HISTORIC AND DESIGN REVIEW COMMISSION

HDRC CASE NO: 2021-049
ADDRESS: 202 BUSHNELL
LEGAL DESCRIPTION: NCB 6328 BLK 1 LOT 12,13,14, 15, 41,42,43,44, E 1.87 OF 11 & 40, W 38.8 OF 16 & 45
ZONING: R-5, H
CITY COUNCIL DIST.: 1
DISTRICT: Monte Vista Historic District
APPLICANT: Daniela Serna/SERNA ANTONIO IV & DANIELA GONZALES DE
OWNER: Daniela Serna/SERNA ANTONIO IV & DANIELA GONZALES DE
TYPE OF WORK: Driveway gate
APPLICATION RECEIVED: January 22, 2021
60-DAY REVIEW: Not applicable due to City Council Emergency Orders
CASE MANAGER: Rachel Rettaliata

The applicant is requesting a Certificate of Appropriateness for approval to install a 5-foot-tall wrought iron driveway gate set back from the existing front stucco with 4-foot-tall sections of wrought iron fencing.

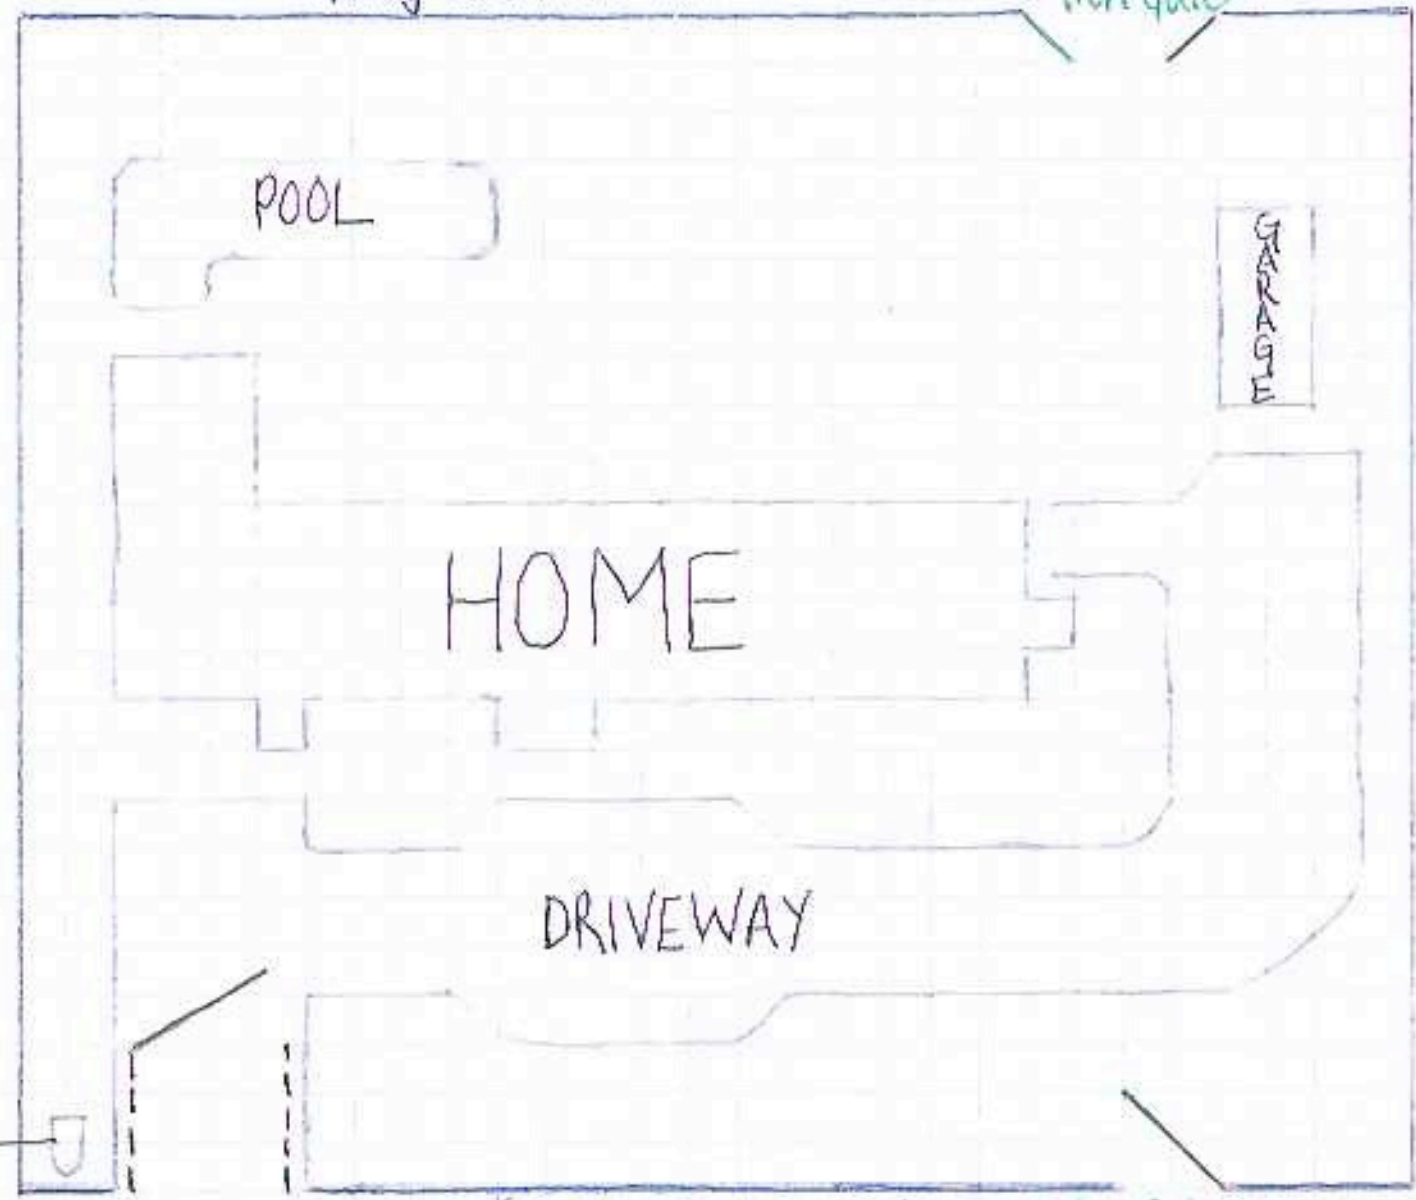
- c. **GATE LOCATION** – The applicant has proposed to install a 5-foot-tall wrought iron driveway gate set back approximately 16 feet from the existing front stucco perimeter wall. The proposed driveway gate will connect to the existing stucco perimeter wall by 4-foot-tall wrought iron fencing installed along the front 17 feet of the driveway on the east and the front 16 feet of the driveway on the west. According to the Historic Design Guidelines, new front yard fences should follow historic fence placements in the district. The applicant has provided evidence that front driveway gates set back from the front yard fence have been installed at other properties on the block. Staff finds the proposal consistent with the Guidelines.

Staff recommends approval of the front driveway gate and fencing installation based on findings a through c with the following stipulation:

- i. That the maximum height at the peak of the driveway gate is 5 feet.
- ii. That the final construction height of the approved gate and fencing may not exceed the maximum height of 4 feet as approved by the HDRC at any portion of the fence. Additionally, the gate and fencing must be permitted and meet the development standards outlined in UDC Section 35-514.

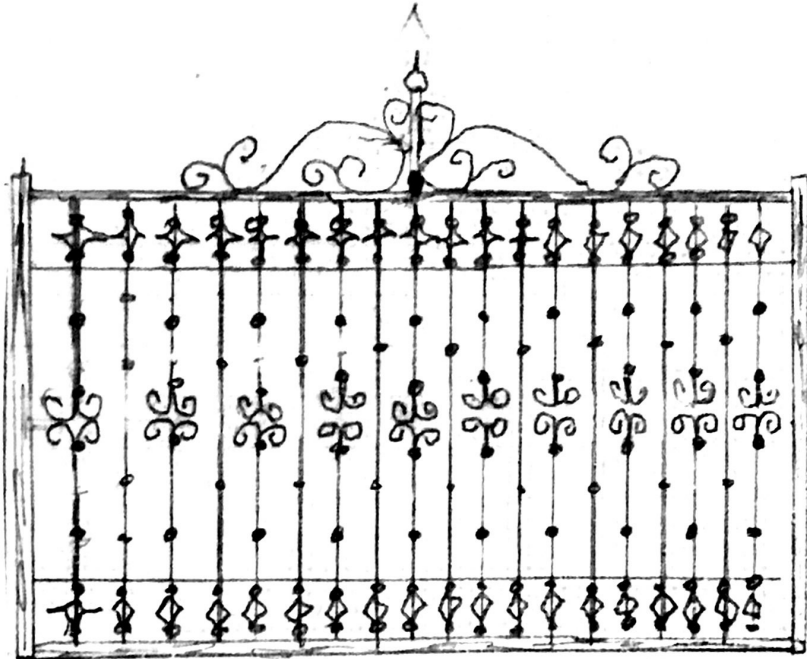
- b. **GATE DESIGN AND HEIGHT** – The applicant has proposed to install a 5-foot-tall wrought iron driveway gate. The proposed driveway gate will connect to the existing stucco perimeter wall by 4-foot-tall wrought iron fencing installed along the driveway. The wrought iron driveway gate and fence design will follow the pattern of the existing front entry gate. According to the Historic Design Guidelines, new front yard fences should appear similar to those used historically within the district in terms of their scale, transparency, and character. Guideline 2.B.iii for Site Elements states that the height of new fences and walls within the front yard should be limited to a maximum of four feet. The appropriateness of a front yard fence is dependent on conditions within a specific historic district. Staff finds that traditional wrought iron fencing is generally appropriate for the Monte Vista Historic District. Staff finds that due to the ornamental detail at the top of the gate, it is appropriate for the driveway gate to extend to 5 feet at its highest point.
